DEPARTMENT OF THE ARMY  
Omaha District, Corps of Engineers  
106 South 15th Street  
Omaha, Nebraska 68102-1618

Amendment No. 0002  
18 January 2002

SUBJECT: Amendment No. 0002 to Specifications and Drawings for Construction of Lewis and Clark Visitor Center Parking Area, Gavins Point Dam - Lewis & Clark Lake, Missouri River, Nebraska and South Dakota.  
Solicitation No. DACW45 02 B 0003.

Drawing Code MG280-110  
Sheet C1.01

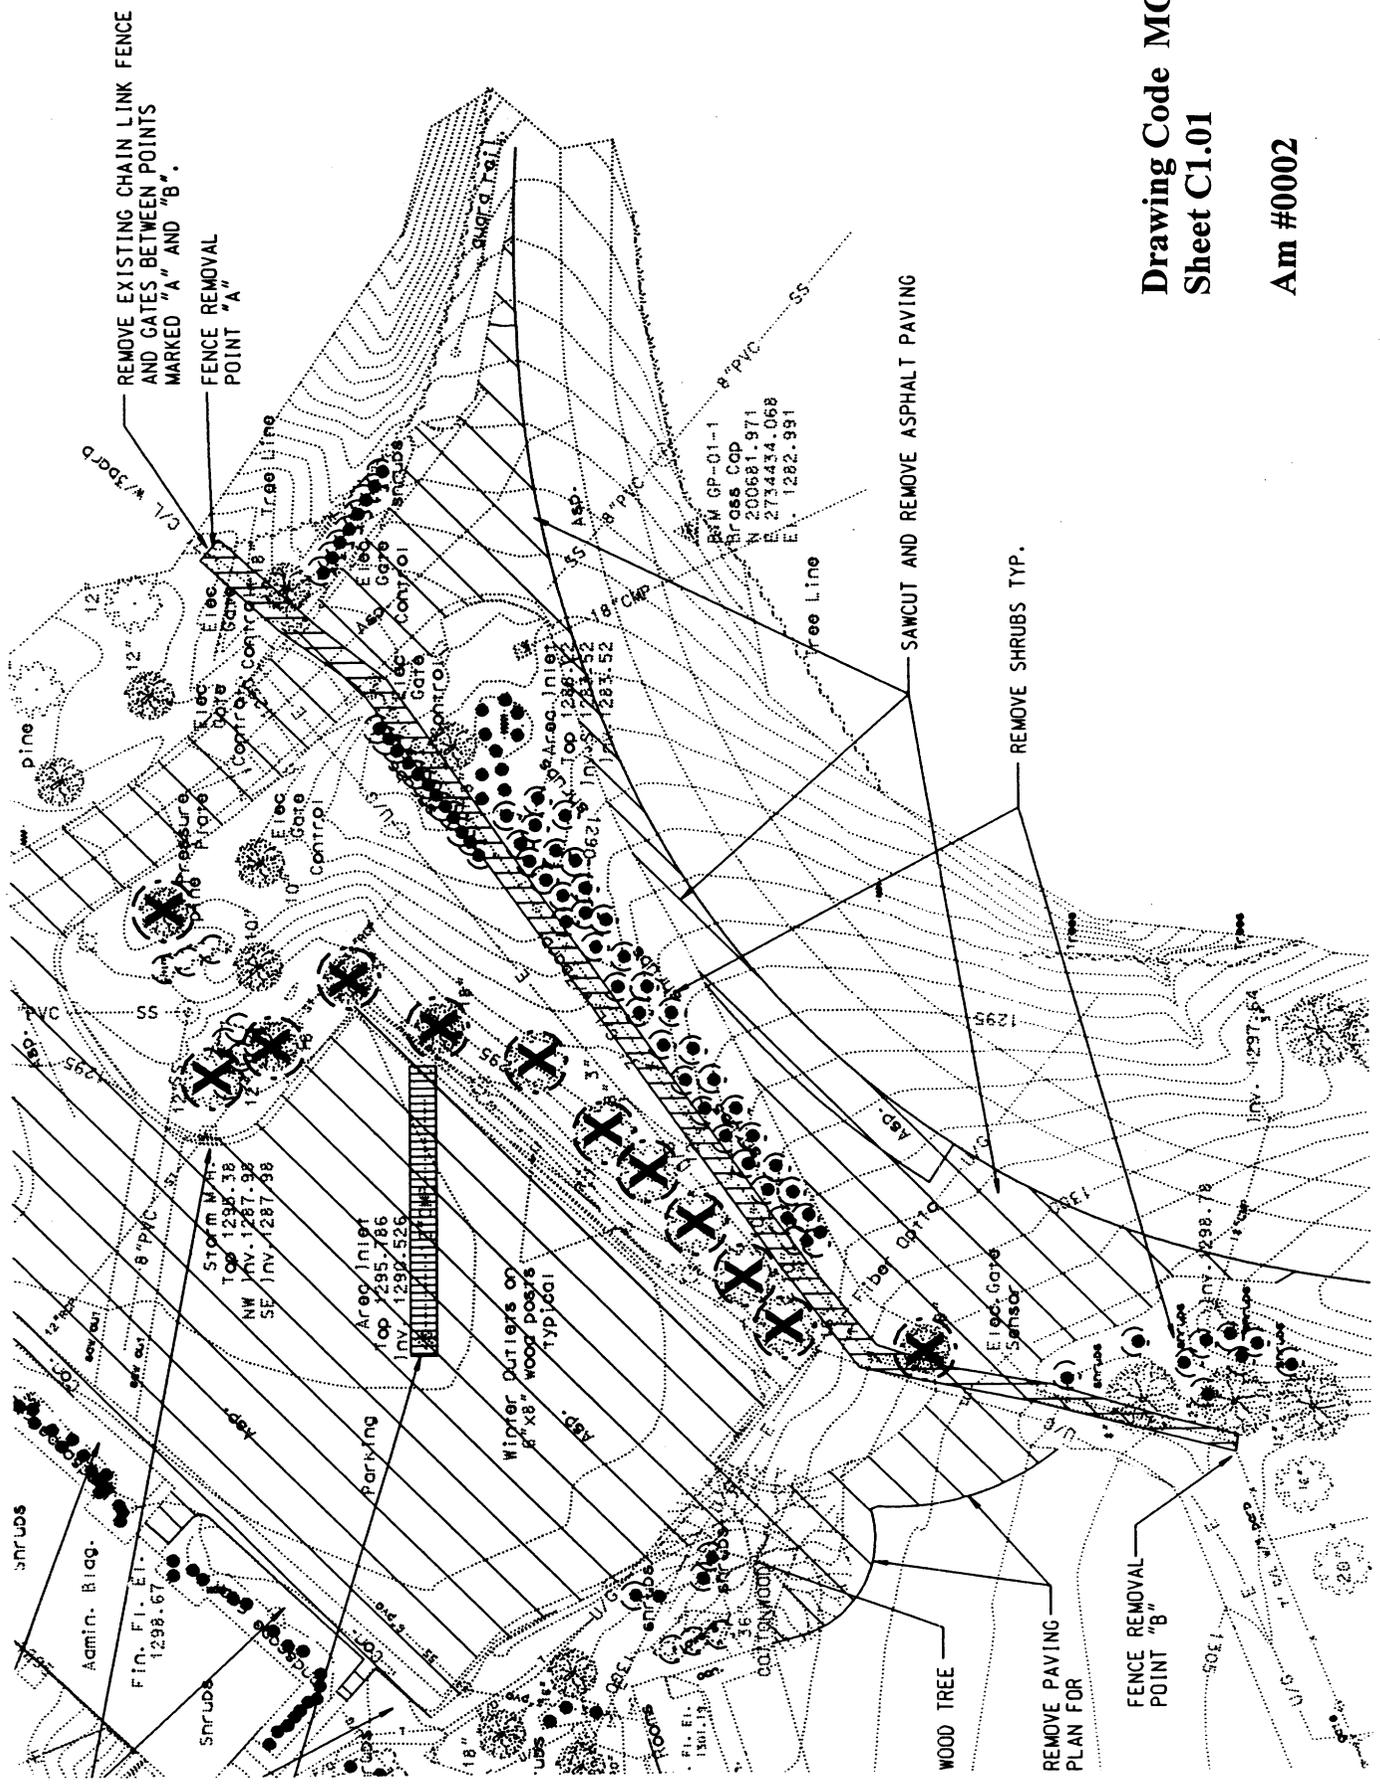
(2) Sheet C1.01,

- a) Revise the sheet as shown on the attached sheet.
- b) See the circles indicating shrubs, (located south of the main entrance to the Visitor Center, in drawing grid D,3, near sidewalk removal reading "REMOVE SIDEWALK TO CORNER OF BUILDING"), add leader pointing to the circles and leader note reading "REMOVE EXISTING SHRUBS".

- c) See Drawing grid C-D,3 replace leader note pointing to removal of storm drain line south of the Visitor Center with the following, "Remove existing inlet and entire length of storm drain line and headwall. Repair slope to existing conditions."

- d) Note 2, Delete the words "and waste paving materials" from the note.
- e) See Drawing grid D3, indicate a flag pole south of the entrance to the Visitor's Center, add the following note to the existing flagpole, "Remove flagpole and entire concrete foundation. Depth of foundation may be over 6 feet."

- f) Add the following notes to the list of notes:
  3. Contractor's staging and storage area will be at the existing Project Service Area located ½ mile to the east of the Visitor Center on the existing highway.

4. Contractor shall plan construction to allow visitors access to the Visitor Center at all times. Contractor shall plan for paved walkways to lead to the Visitor Center from the Picnic Shelter Area or from the existing parking lot south of the Administration Building, to be used by the public.

5. Contractor shall assume that all existing asphalt paving indicated to be removed shall exist as a 3" layer of asphalt with a 10" layer of base course.

6. All existing asphalt material indicated to be demolished and removed from the site shall be milled and stockpiled at the Project service
